UNITED STATES PATENT AND TRADEMARK OFFICE

APPLICATION NO.	FILING DATE	FIRST NAMED INVENTOR	ATTORNEY DOCKET NO.	CONFIRMATION NO.
10/799,898	03/12/2004	Rick Huffman	2503343-991100	8313
29585	7590	07/21/2006	EXAMINER	
DLA PIPER RUDNICK GRAY CARY US LLP 153 TOWNSEND STREET SUITE 800 SAN FRANCISCO, CA 94107-1907			GREENE, DANIEL LAWSON	
			ART UNIT	PAPER NUMBER
			3663

Office Action Summary	Application No. 10/799,898	Applicant(s) HUFFMAN, RICK	
	Examiner Daniel L. Greene Jr.	Art Unit 3663

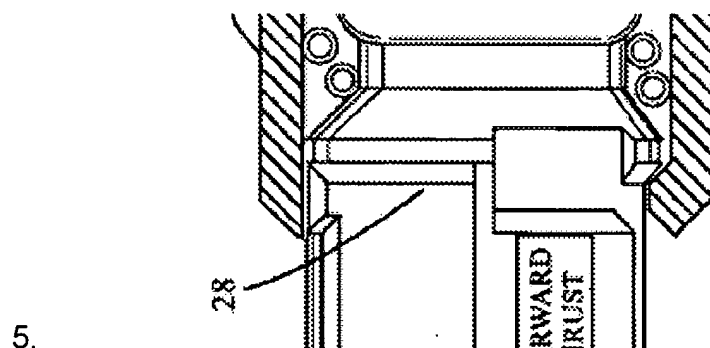
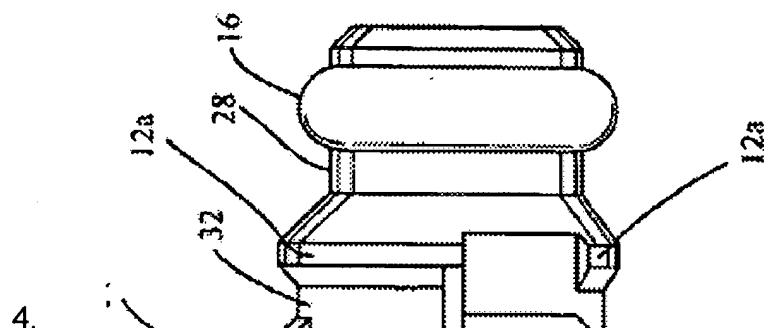
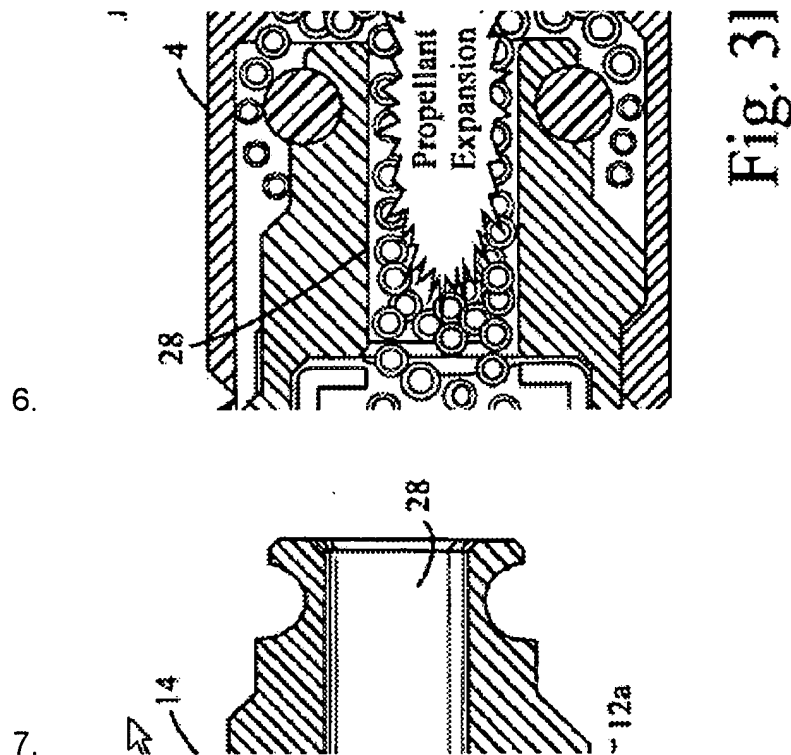
A review of the manner in which the specification was amended, in order to define exactly what item 28 is, when referenced to the drawings, creates doubt as to what exactly applicant is attempting to define because item 28 is a narrow cylindrical portion (page 13, last line), however the specific metes and bounds of this cylindrical portion have not been set forth. It appears that according to at least figures 2B and 3B the narrow cylindrical portion extends almost half way from the beveled tip towards the third end portion 36, however according to Figure 1D it would appear the portion only extends from the beveled end to the cog portion.

8. The drawings are still objected to for the reasons set forth in sections 3A and 3B of the 9/9/2005 Office Action because it is still unclear exactly what applicant is defining as items 28 and 32.

C. The rest of the amendments to the specification are also objected to as the drawings do not reflect what Applicant has amended the specification to say because Item 28 is still labeled as multiple items by the drawings themselves

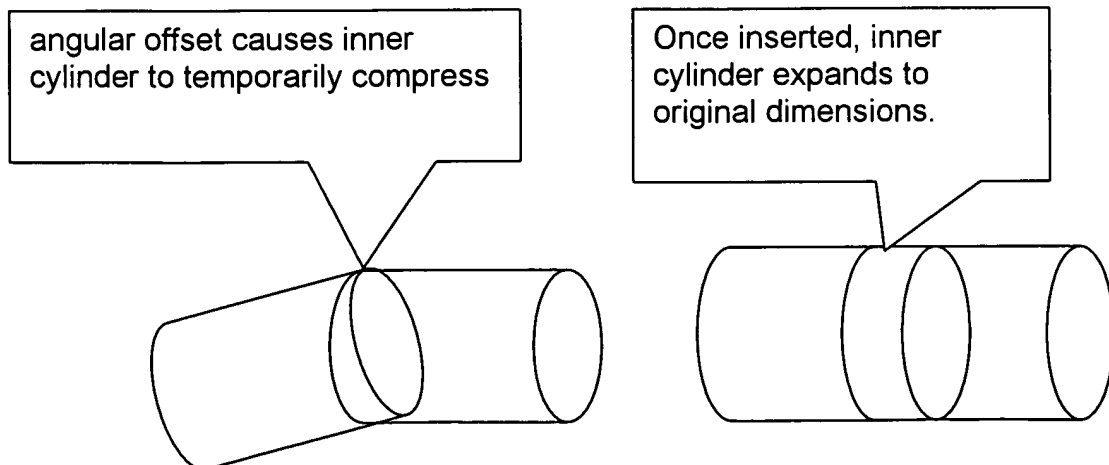
In response to applicant's argument that the references fail to show certain features of applicant's invention, it is noted that the features upon which applicant relies (i.e., partially annular) are not recited in the rejected claim(s). Although the claims are interpreted in light of the specification, limitations from the specification are not read into the claims. See *In re Van Geuns*, 988 F.2d 1181, 26 USPQ2d 1057 (Fed. Cir. 1993). Further in this regard, the instant claim language is not closed ended, i.e. the claim states "comprising...one or more protrusion portions". Clearly enough protrusion portions would surround the entire piston sleeve just as in Saxby.

Applicant's arguments are unpersuasive as applicant has not shown that the references do not teach what the examiner has stated they teach, nor has applicant shown that the examiner's reasoning for and manner of combining the teachings of the references is improper or invalid. The difference in operation of the claimed invention does not alleviate the fact that the reference contains each and every limitation found in the instant claim language.

Further, although applicant states the assembly procedure of Saxby, there is no reason they cannot be assembled by relative angular offset and compression of the inner cylinder by for example;
